LCV-1617

VOGTLE ELECTRIC GENERATING PLANT  
REQUEST TO REVISE TECHNICAL SPECIFICATIONS  
REACTOR TRIP SYSTEM INSTRUMENTATION OVER TEMPERATURE DELTA  
TEMPERATURE (OTAT) AND OVERPOWER DELTA TEMPERATURE (OPAT)  
REACTOR TRIP FUNCTIONS

In accordance with the requirements of 10 CFR 50.90, Southern Nuclear Operating Company (SNC) proposes to revise Vogtle Electric Generating Plant (VEGP) Unit 1 and Unit 2 Technical Specifications (TS) Figure 2.1.1-1, "Reactor Core Safety Limits"; Table 3.3.1-1, "Reactor Trip System Instrumentation"; and the associated Bases B2.1.1 and B 3.3.1.

Figure 2.1.1-1  
Reactor Core Safety Limits

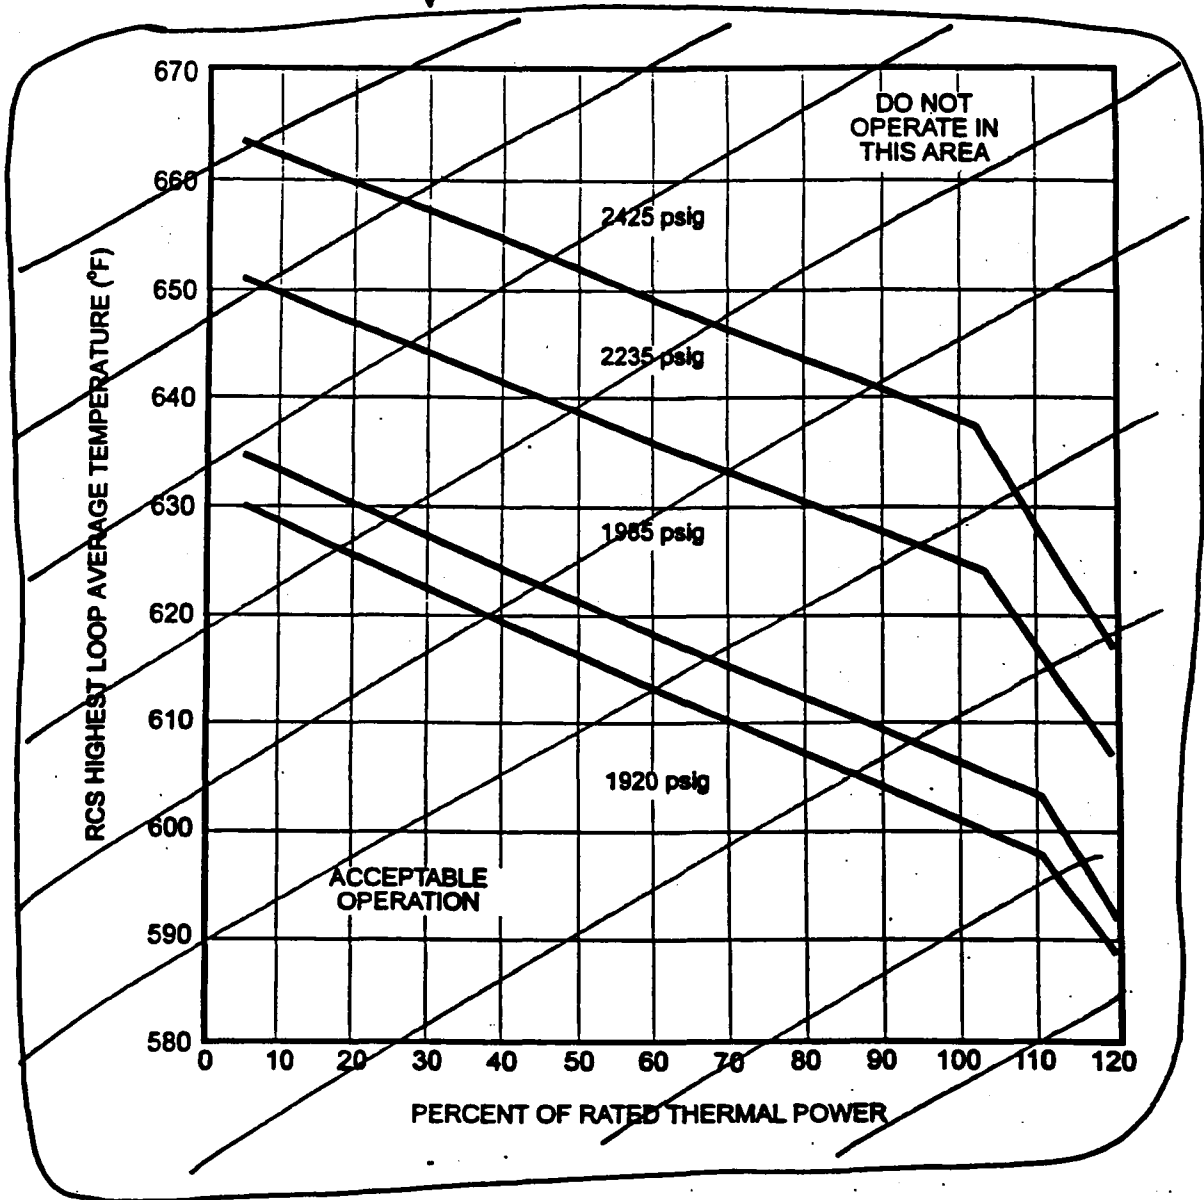
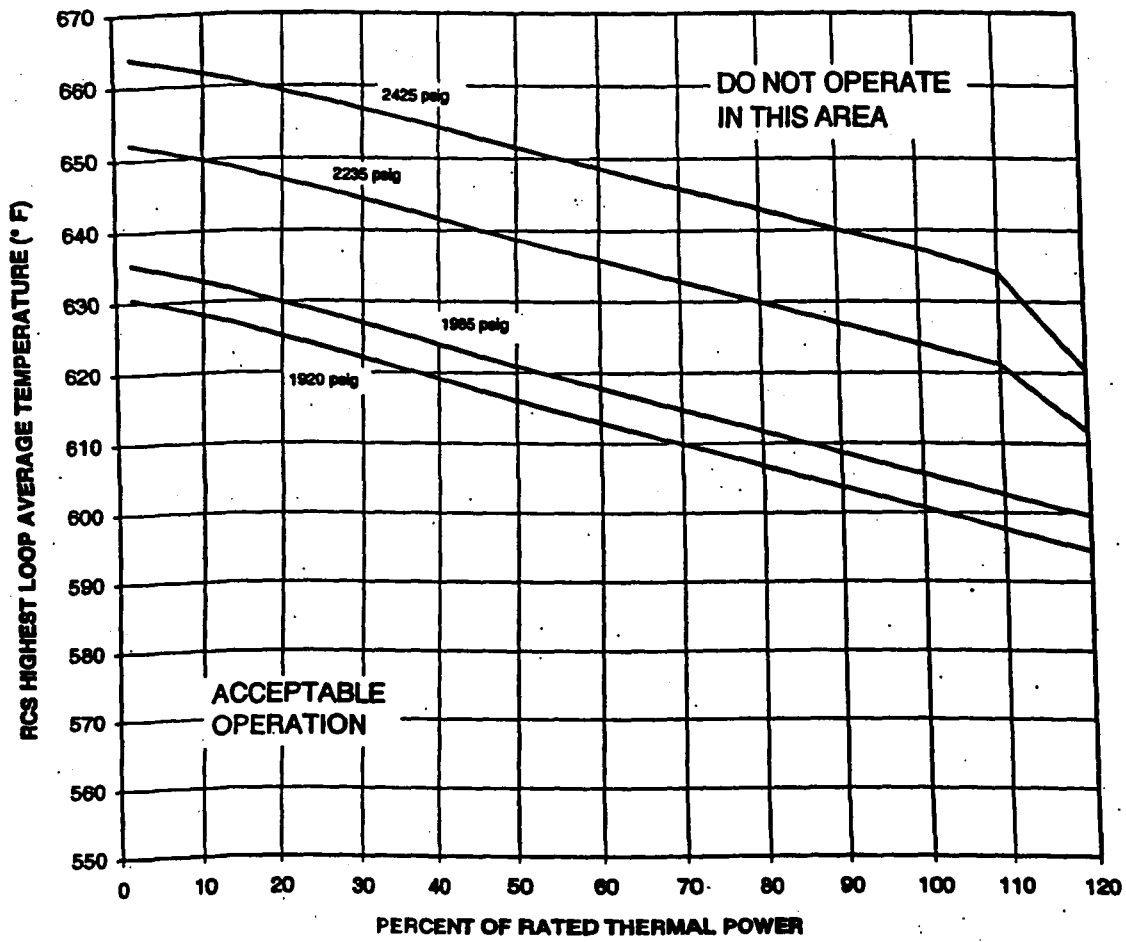
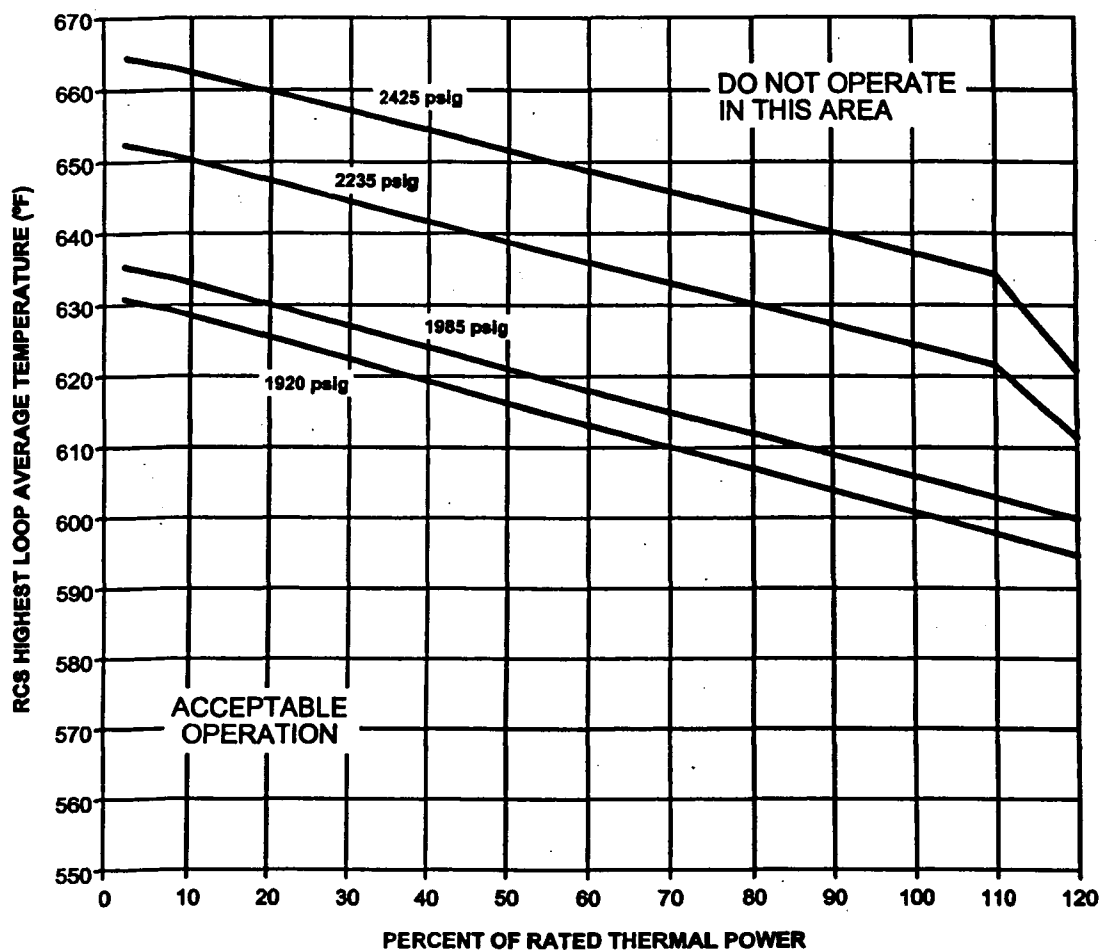
In accordance with the requirements of 10 CFR 50.90, Southern Nuclear Operating Company (SNC) proposes to revise Vogtle Electric Generating Plant (VEGP) Unit 1 and Unit 2 Technical Specifications (TS) Figure 2.1.1-1, "Reactor Core Safety Limits"; Table 3.3.1-1, "Reactor Trip System Instrumentation"; and the associated Bases B2.1.1 and B 3.3.1.

To support the revised OTΔT and OPΔT trip setpoints for the VEGP MRP, the DNB core thermal limit lines for VEGP were revised from the current limits. For the current VEGP DNB core thermal limits, the LOPAR fuel is the most limiting fuel design. The revised DNB core thermal limits for the VEGP MRP are based on VANTAGE+ as the most limiting fuel design. The  $F_{\Delta H}$  limit for the VANTAGE+ fuel remains at the current value of 1.65. The VANTAGE+ safety analysis DNBR limits for the MRP analysis were reduced by decreasing the DNBR margin which was retained in the current safety analysis DNBR limits. The DNBR margin (approximately 17%) which was previously retained was necessary to offset the transition core DNBR penalty associated with the first LOPAR-to-VANTAGE-5 transition cycle. Since the current VEGP core designs are primarily VANTAGE+ (or all VANTAGE+), the amount of retained DNBR margin needed to address any limited reinsertion of LOPAR fuel assemblies is significantly reduced. The new reduced VANTAGE+ safety analysis DNBR limits resulted in less restrictive DNB core thermal limits to support the improved OTΔT trip setpoints.

Revised core thermal limits were calculated for the VEGP MRP. The core limits are revised to account for a higher Minimum Measured Flow to be consistent with the current reactor coolant system flow measurement uncertainty, a decrease in the core bypass flow (assumes thimble plugs installed), the removal of the fuel transition core penalty (core limits are applicable to VANTAGE-5 and VANTAGE+ fuel), and an overpower limit increase from 118% to 120%.

INSERT A

INSERT A
